MAJOR ALTERATIONS + ADDITIONS TO
THE STEVENSON LIBRARY (SSD 8922)

S4.55 Modification Application

S4.55-2 MODIFICATION APPLICATION

1 Proposed Eastern Elevation + Context
Scale: 1:200

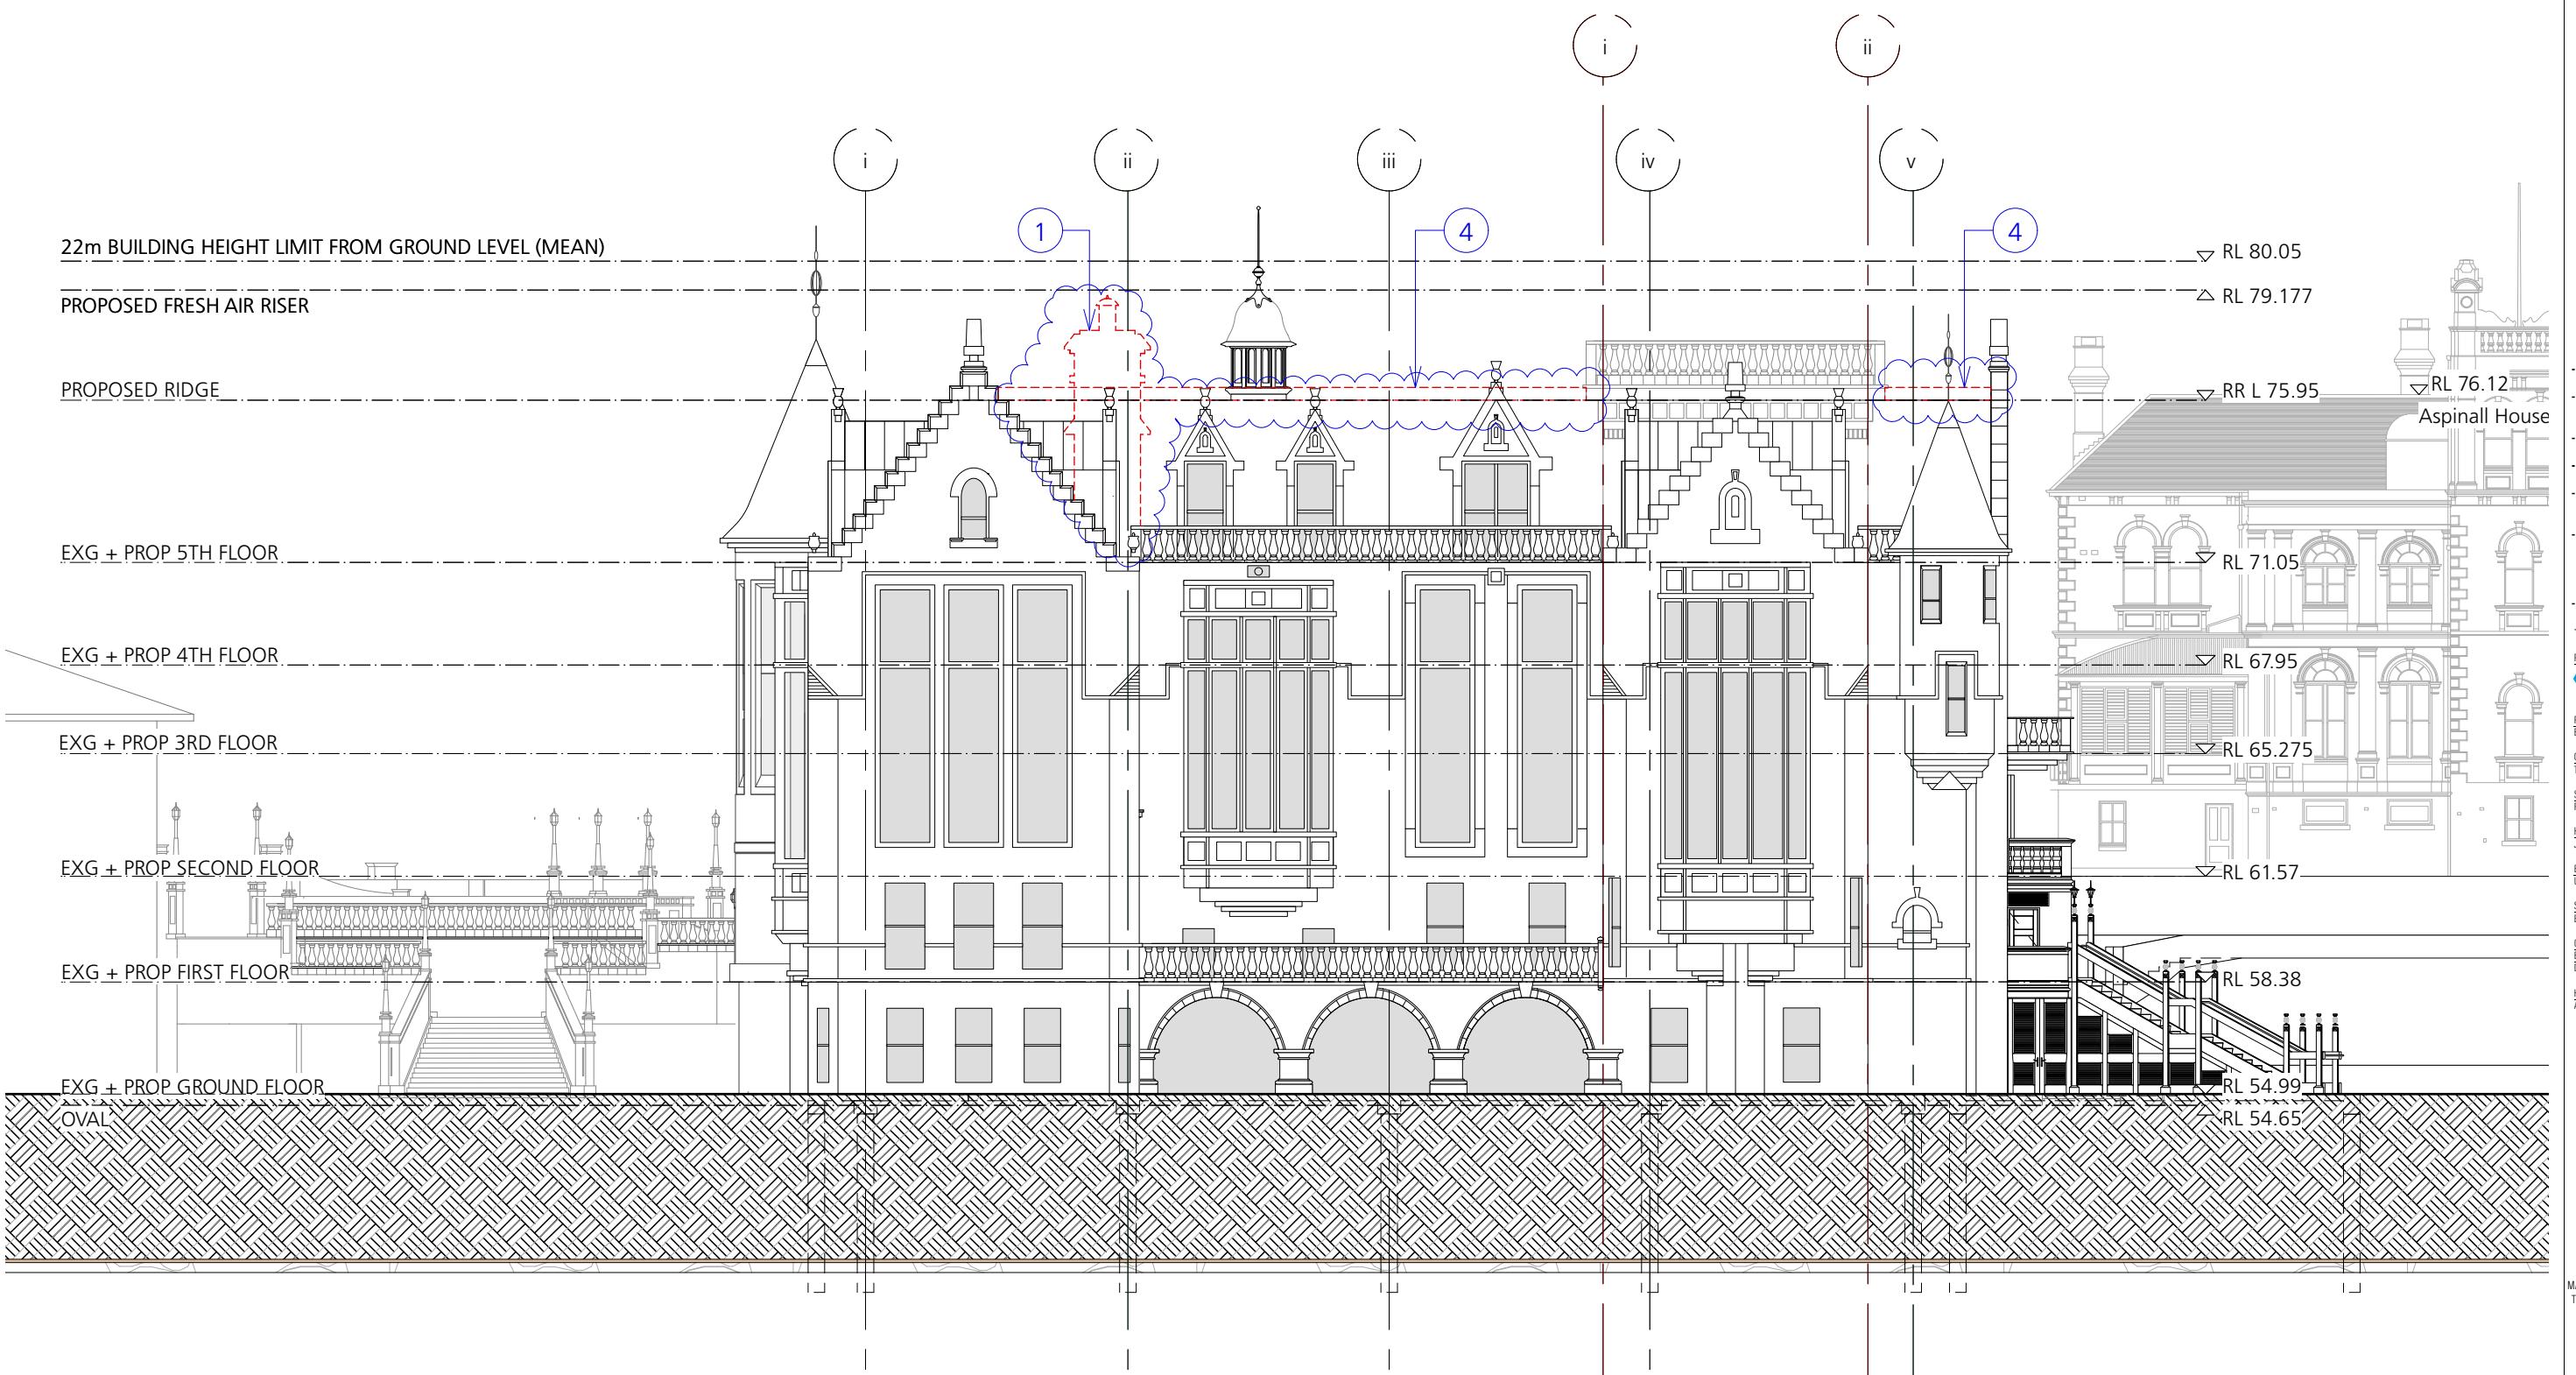
1. CHIMNEY DELETED.
2. TWO FRESH AIR LOUVRES ADDED.
3. REDUCED PROFILE OF TWO DORMERS TO SOUTHERN FAÇADE
4. RIDGE CREST DELETED.

3 Proposed Southern Elevation
Scale: 1:200

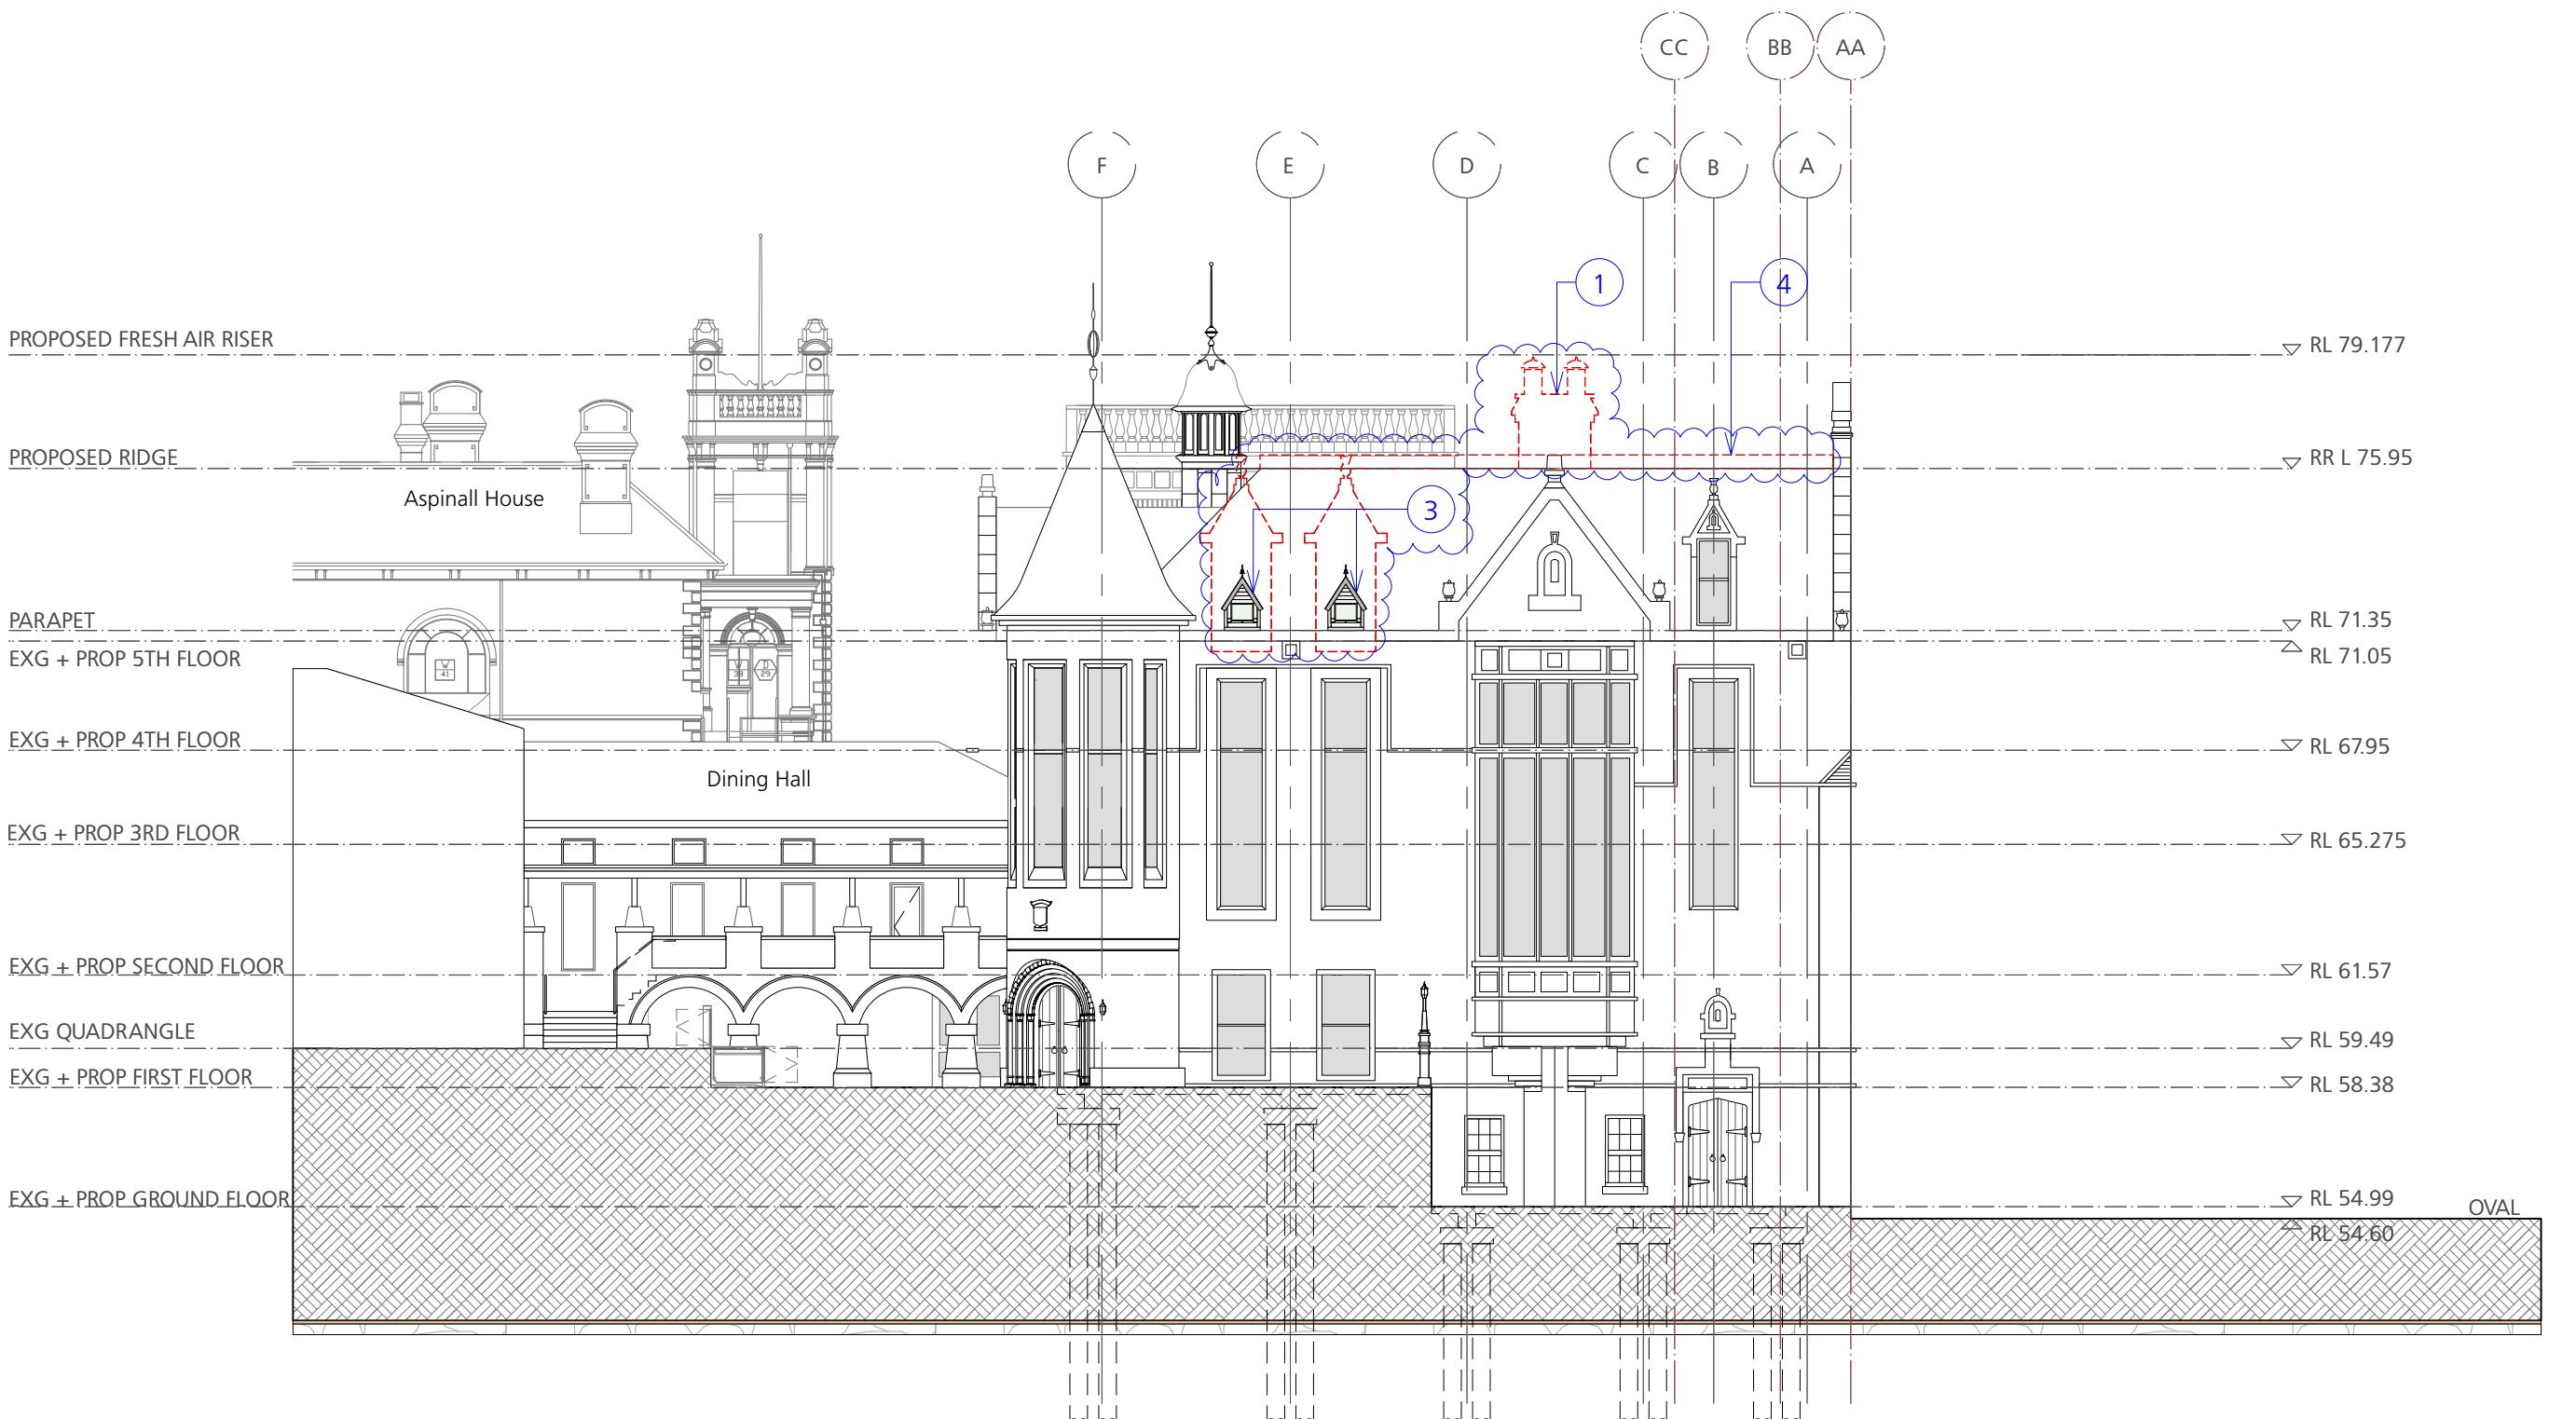
1. CHIMNEY DELETED.
2. TWO FRESH AIR LOUVRES ADDED.
3. REDUCED PROFILE OF TWO DORMERS TO SOUTHERN FAÇADE
4. RIDGE CREST DELETED.

1 Proposed Western Elevation
Scale: 1:200

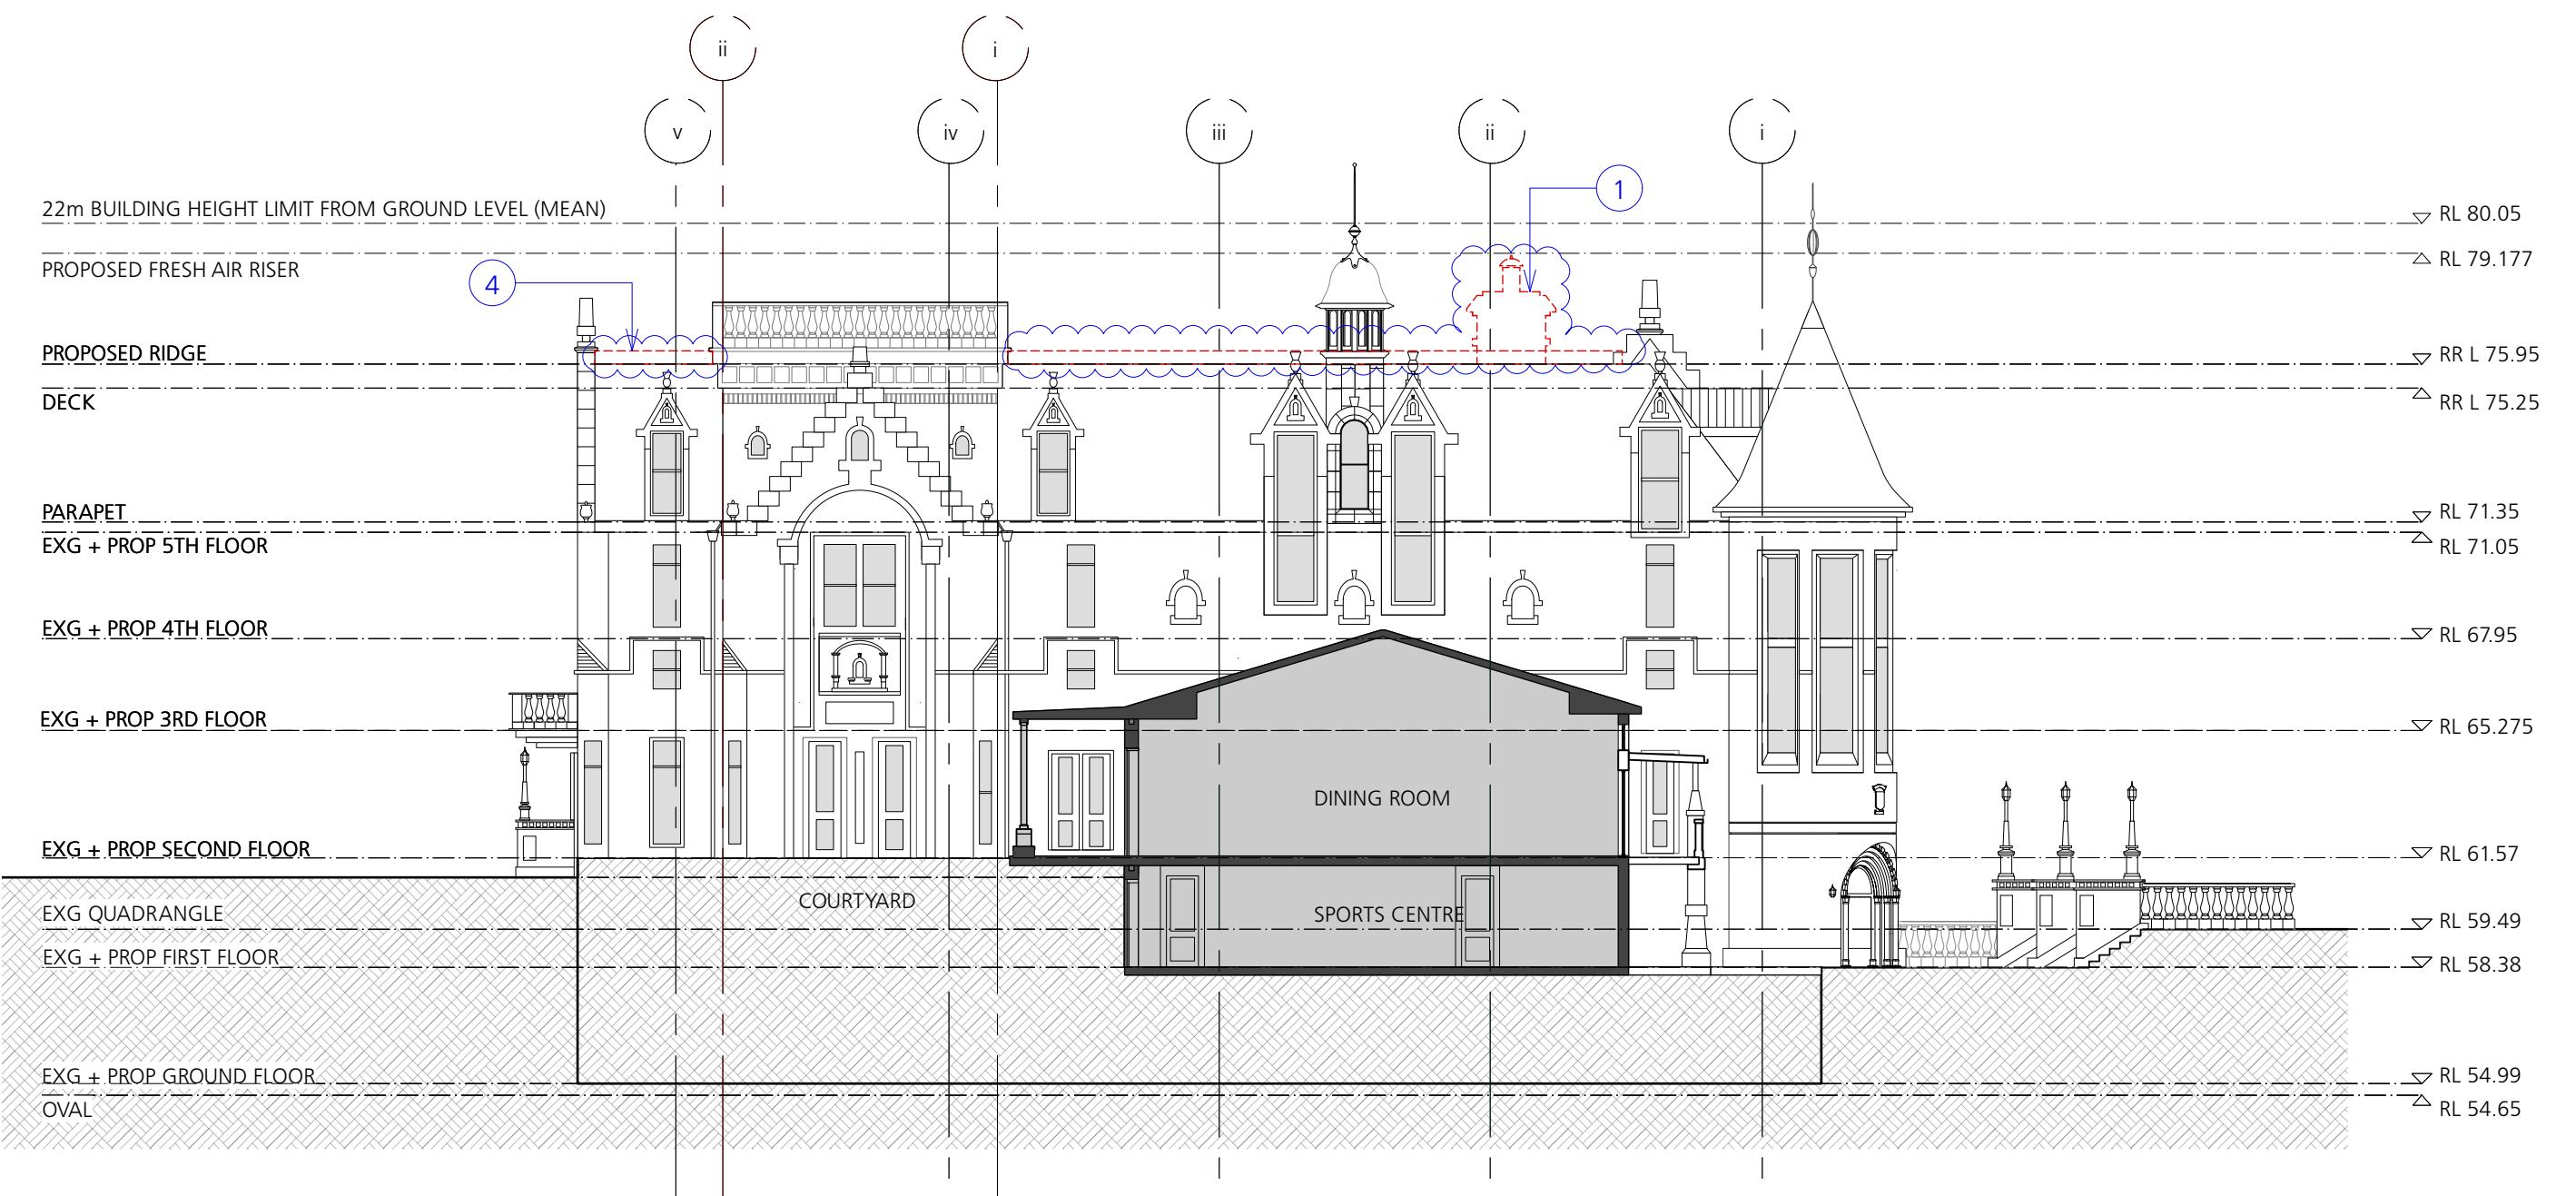
1. CHIMNEY DELETED.
2. TWO FRESH AIR LOUVRES ADDED.
3. REDUCED PROFILE OF TWO DORMERS TO SOUTHERN FAÇADE
4. RIDGE CREST DELETED.
